**'Montana', 281 Mountain View Road [NAD #]**

**IPC Presentation, Speaker #54, 1<sup>st</sup> February 2024**

# Visual impact

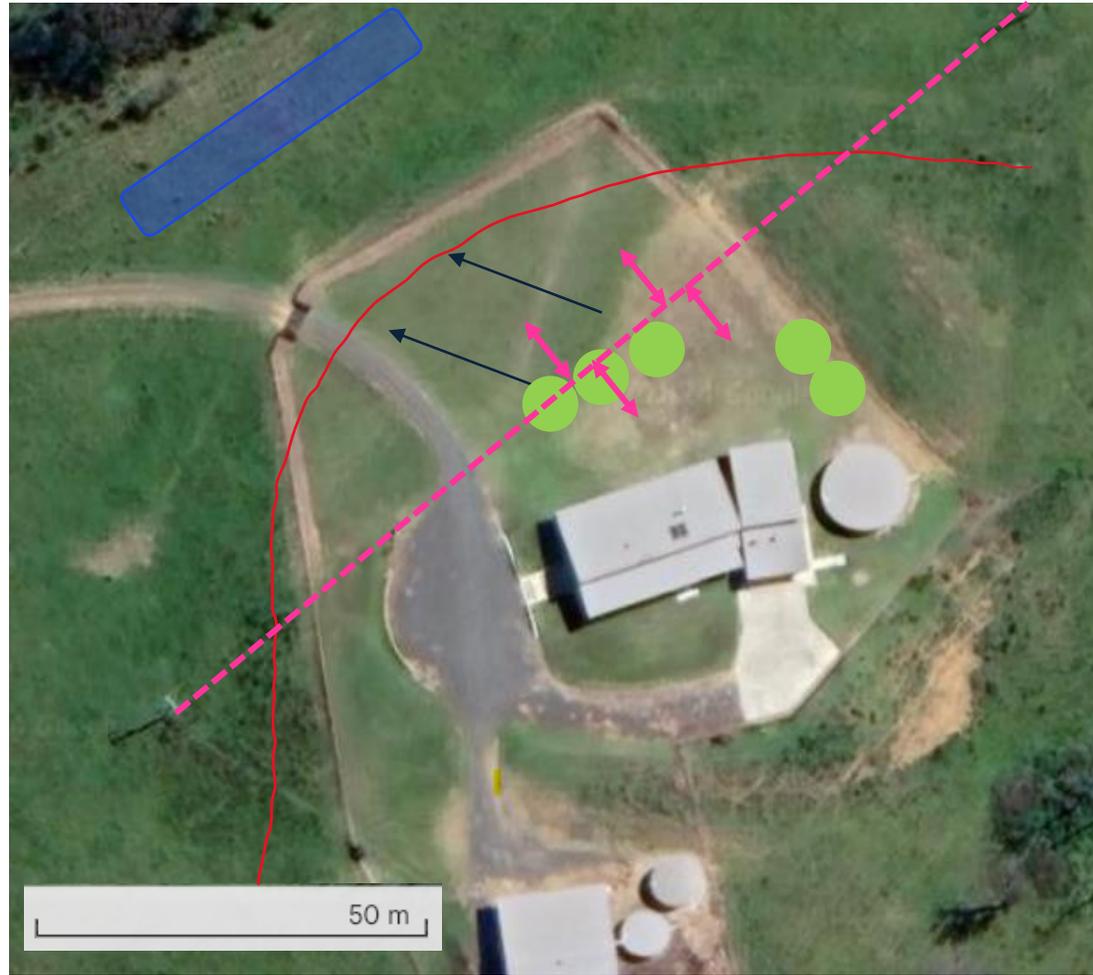
○ 6 high visual impact turbines – 16, 18, 20, 21, 25 & 26

Support removal of turbines 9, 10, 11, 24 & 28
